Prepared for
Health Infrastructure NSW

Date
4 February 2026

Appendix A – Submissions Register

New Rouse Hill Hospital

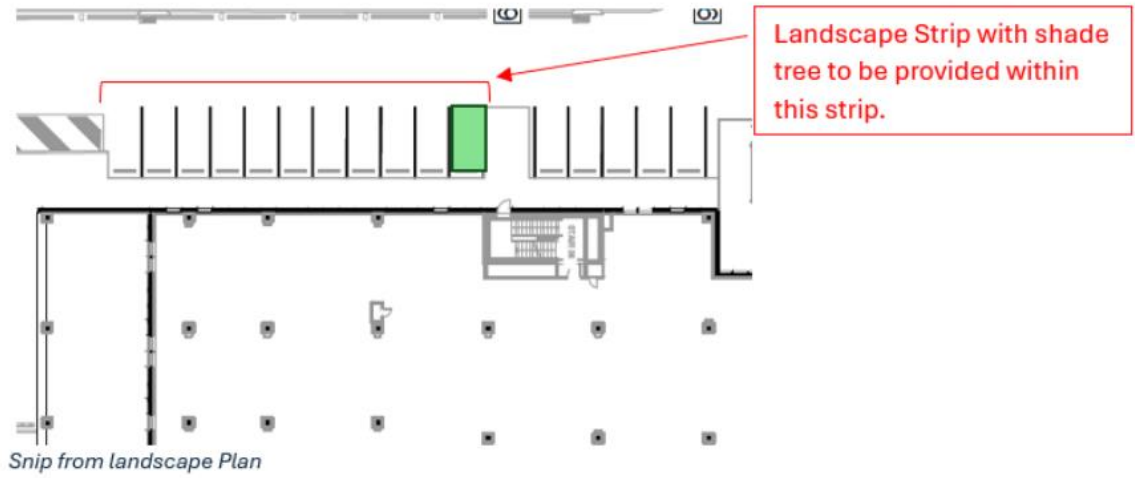
<p>As per DCP Part C Section 3.12. Car parking -(c) Outdoor parking areas are to be screened by a minimum of two-metre-wide landscaping strips. Such landscaping is to be of a mature and dense nature.</p>	
<p>Car parking to be designed in accordance with THSDCP Part C Section 3 – Landscaping Clause 3.12 Car Parking, and Part C Section 1-Parking. Two-metre-wide Landscape strips are to be provided between rows served by</p>

different aisles and between spaces at a rate of one in every ten car parking spaces. Shade trees are to be provided within the landscape strips. (See snip Below)

Figure 13: Daily parking accumulation profile for staff, patients and visitors

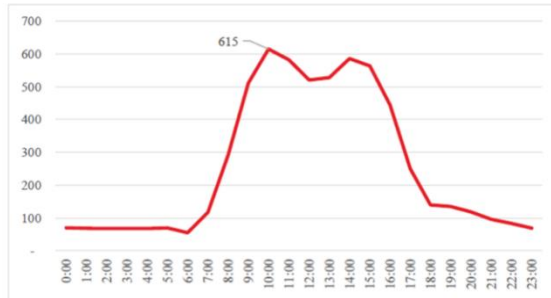
Issue	Response
<p>The report only provides sizes of site/development as shown below. More detailed information needs to be provided to assist in understanding how the trips rates were derived and any assumption associated</p> <p>The trips have been revised compared to the initial study however the size of the development has increased from 15,000m2 to 39,100 m2 (excluding the proposed multistorey car park of 13,750 m² GFA). This represents more than a twofold increase in GFA. However, the corresponding revised trips have not increased in proportion to the increase in development size as expected. The revised trips have a marginal impact on the road network.</p> <p>The TAIA provides parking spaces and person/vehicle trips however it says the rates are based on the Schedule of Accommodation (SoA), other project-specific information from Health Infrastructure, and profile surveys of other Sydney hospitals. No evidence has been provided to support these claims.</p> <p>The peak parking demand is derived from the peak point of a graph in the study however there is no evidence showing how the demand and peak period axes were determined.</p> <p>Similarly, the peak hour person and vehicle trips are also based on graphs produced by the applicant's traffic consultant with no supporting evidence.</p>

Response

Figure 22: Daily departure/arrival profile for staff (note percentages are rounded)

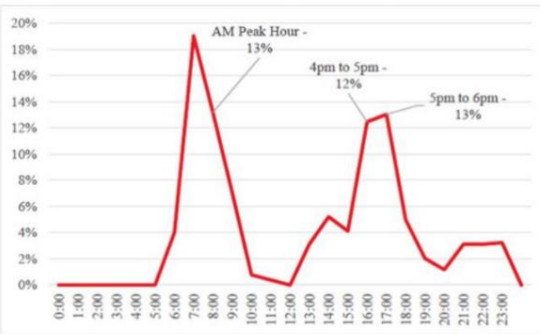
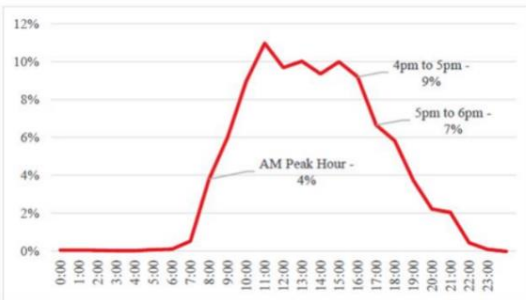
Similarly, the peak hour person and vehicle trips are also based on graphs produced by the applicant's traffic consultant with no supporting evidence.
